PERMIT # 002275

BUILDING PERMIT APPLICATION

LOCATION OF CONSTRUCTION 92-G-31 Woods Rd., Peaks Island

SUBJECT: Review of proposed SSW disposal system design, Steven MacIsaac property, Woods Road, Peaks Island, Portland

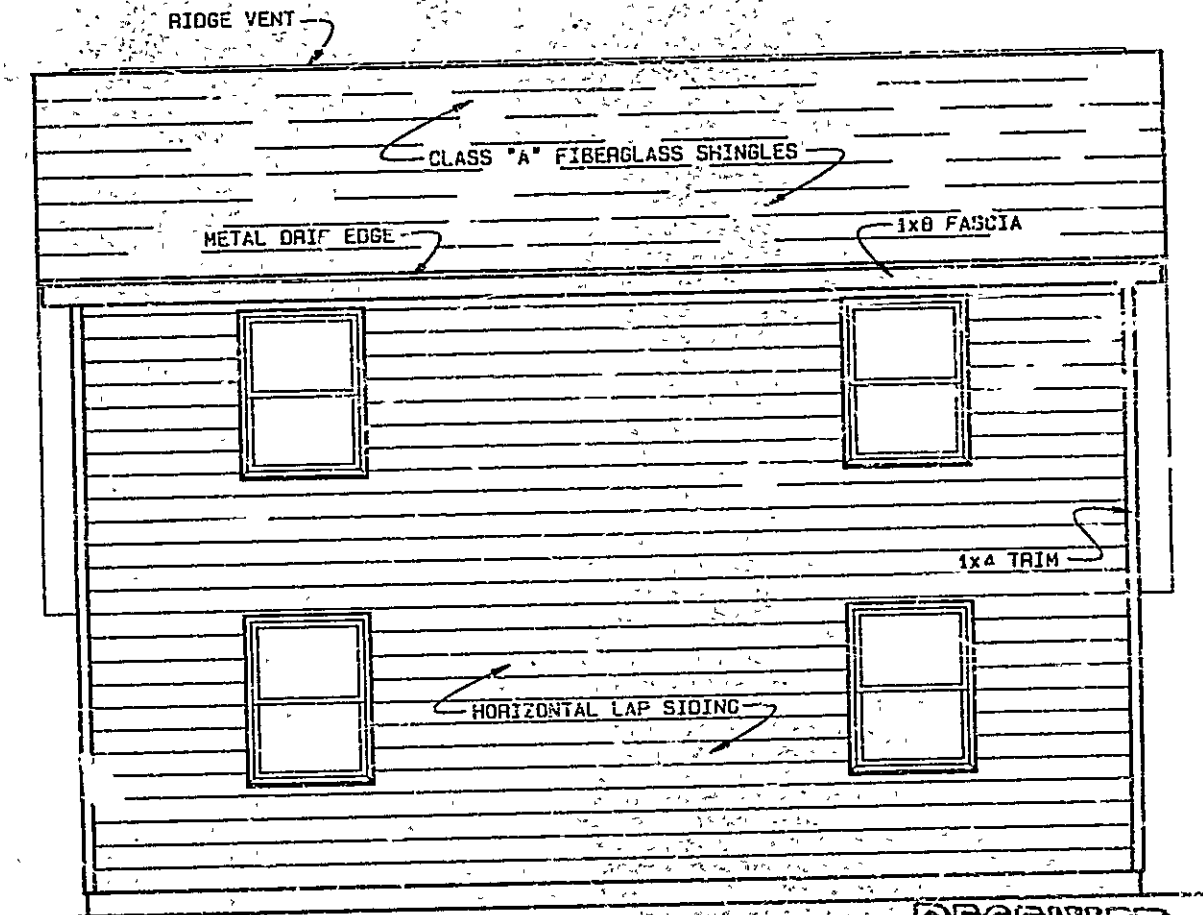
In order to take better advantage of the ocean view from this lot it is proposed that the location of the driveway and the house be switched (see attached site plan - hand drawn figures are proposed sites). The height of the house from the sill to the peak of the roof will be 24 feet, including the foundation it will be 29 feet. The piers underpinning the house will be 5 feet above grade eliminating the need to pump the sewerage to the septic tank.

The overall grading and drainage plan of the lot will not change as a result of this proposal. The drainage swale pictured on the plan will run under the driveway in a culvert as it did on the original plan.

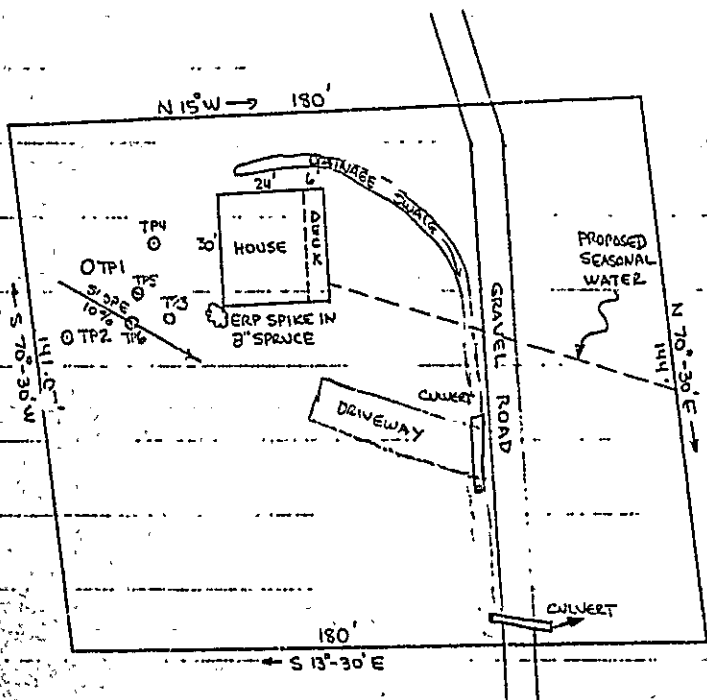
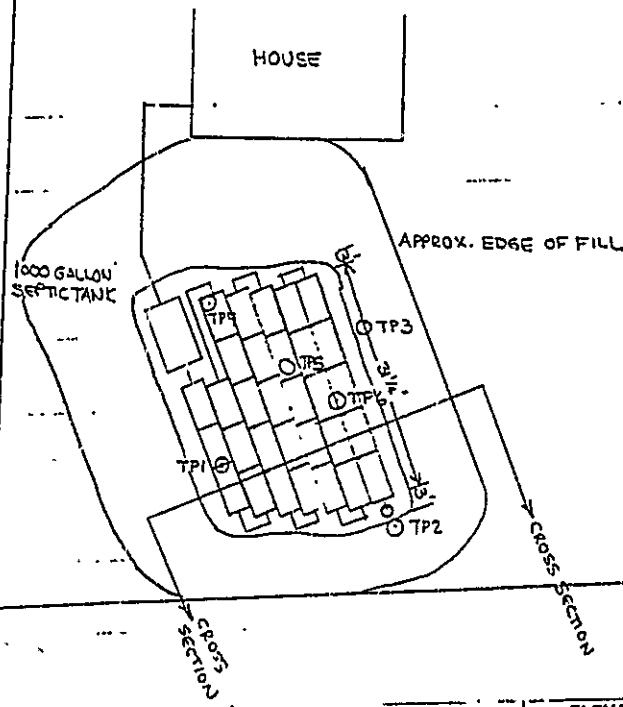
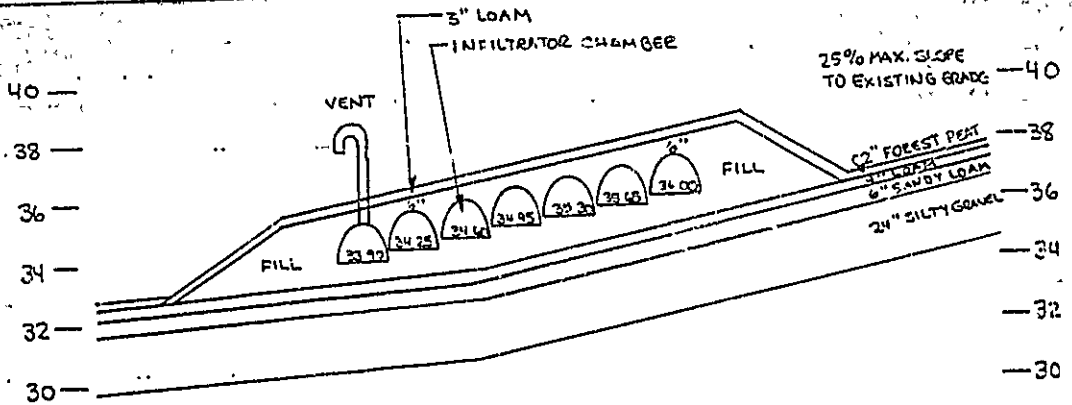
In response to your letter of May 22, 1990 to Mr. Addato (on which I was copied) in reference to the above mentioned revised disposal system design, I have conducted an evaluation of the additional soil test pits required by the Division. This re-evaluation was performed on June 16, 1990. The test pit in the area of the separated laundry system revealed that inadequate mineral soil existed between the 6" organic strata and the ground water table.

Attached please find copies of the revised HHE-200 forms incorporating the revisions we discussed last fall. These forms include the soil test pit logs for the required additional test pits evaluated on June 16, 1990. Three additional acceptable test pits were located in the area of the revised cluster system for a total of five acceptable pits in the area of the system. An additional test pit located between the wetland area and the cluster system, shown as test pit #3 had only 12" between the organic strata and the ground water table rather than the required 15".

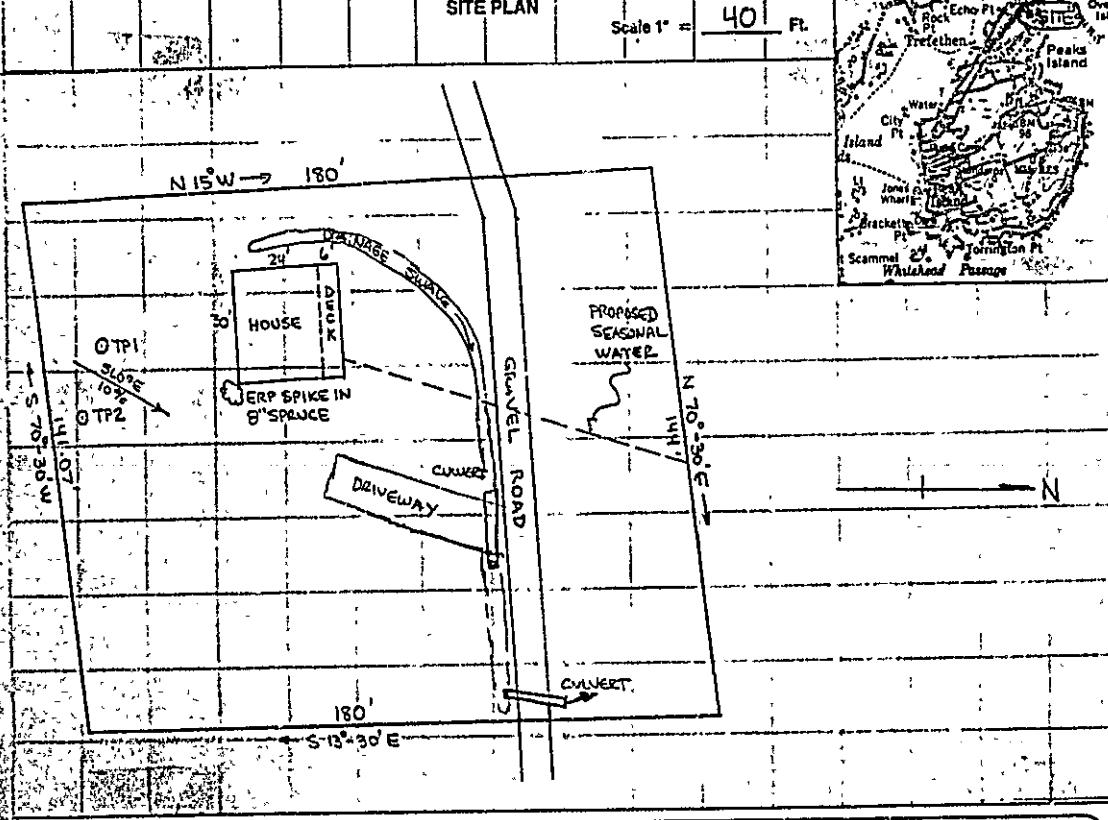
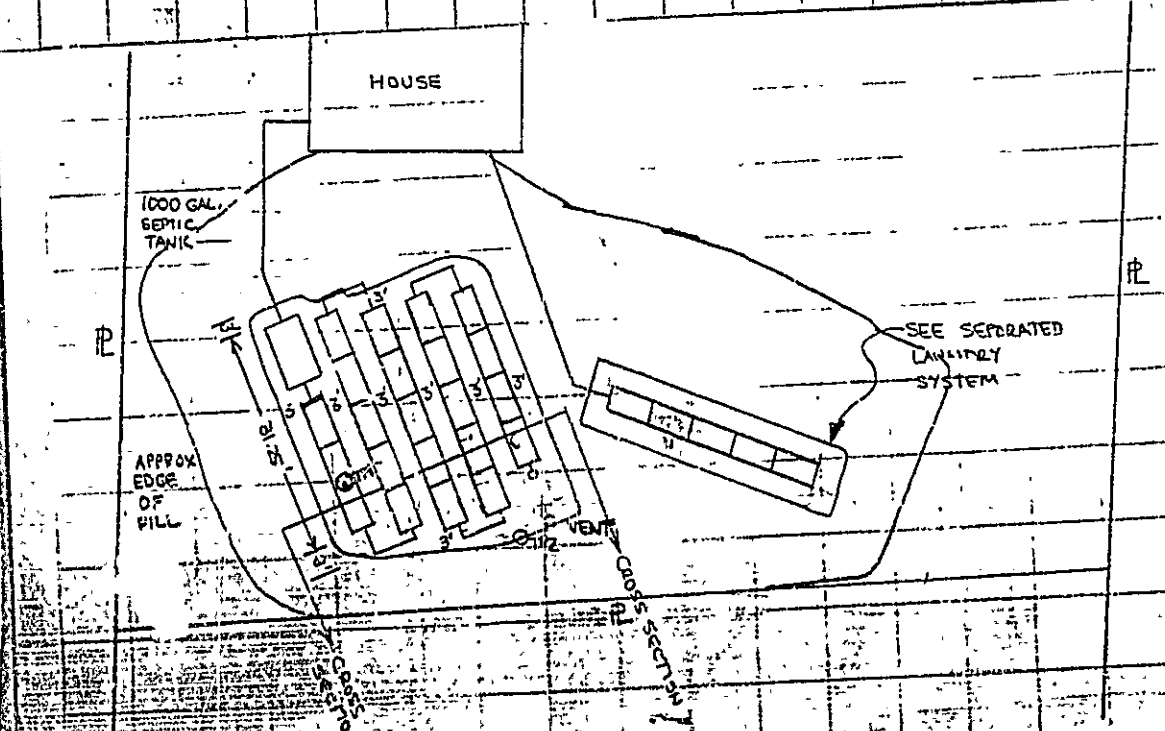
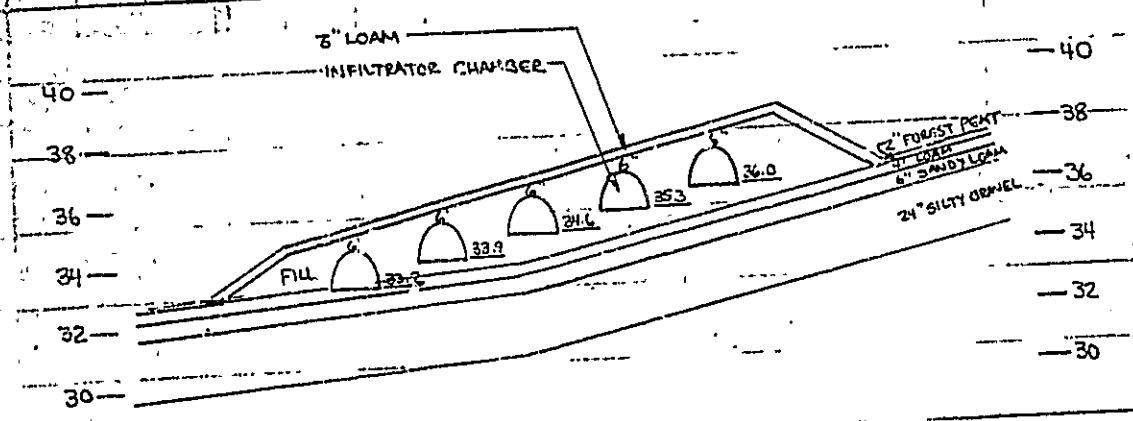
I have reviewed the revised "Subsurface Wastewater Disposal System Application" as prepared by William B. Goodwin and submitted by Steven MacIsaac on April 20, 1990. I note that the soil evaluations are based upon the same two test pits as the previous submission of May 1989. Those evaluations having been conducted by William Goodwin on March 27, 1989. It is my understanding, as a result of inquiries made of your office by my attorneys, that a revised "Topographic Site Plan" could not be located and it was uncertain whether one had been submitted with this Application as required.

I trust you recall the November 6, 1989 site review attended by Jay Hardcastle, William Goodwin, yourself and other City staff. I am also certain that you will recall one of the blatant site plan discrepancies, and one of several which invalidated the sewage system Permit of last June, was the actual location of a rock outcrop within the westernmost row of proposed infiltration chambers.

I overlaid the sewage system plan dated 2 May 89 with the revised system plan dated 28 Nov 89 to note the design changes; both being on page 3 of 3 of the Application forms as prepared by William Goodwin. I discovered several curious things. The system plans are identical; the property lines, house location, laundry system, and lettering on both are perfectly. Two things are not identical. The first is the number of infiltration chambers for the wastewater system in each of the five rows of such chambers; the septic tank was relocated away from the house and into the westernmost row to overcome the inadequate setback from a man-made ditch of the May 1989 submission. However, the location of the five rows of chambers is identical between the two plans, and the westernmost row of chambers on the April 1990 submission is in exactly the same location as the westernmost row of the May 1989 submission. This means the westernmost row in the revised system plan, dated 28 Nov 89, still straddles the rock outcrop observed in the field earlier that month. The second curious thing is the test pit locations are not the same in both plans. The test pit TP1 has been illustrated within the westernmost row of chambers of the 28 Nov 89 plan. I believe this creates the impression that the sewage disposal field has been moved easterly off the rocks. The location of test pit TP2 matches perfectly between the 1989 and 1990 submissions. However, the space between TP1 and TP2 has apparently and inexplicably increased from 20 feet on the plan prepared by Goodwin dated 2 May 89 to 27 feet on the plan prepared by Goodwin dated 28 Nov 89. The Topographic Site Plan, signed and stamped by Registered Land Surveyor Gary E. Johnson, which accompanied the May 1989 Application indicates the two test pits have a spacing of 20 feet. I am greatly concerned this
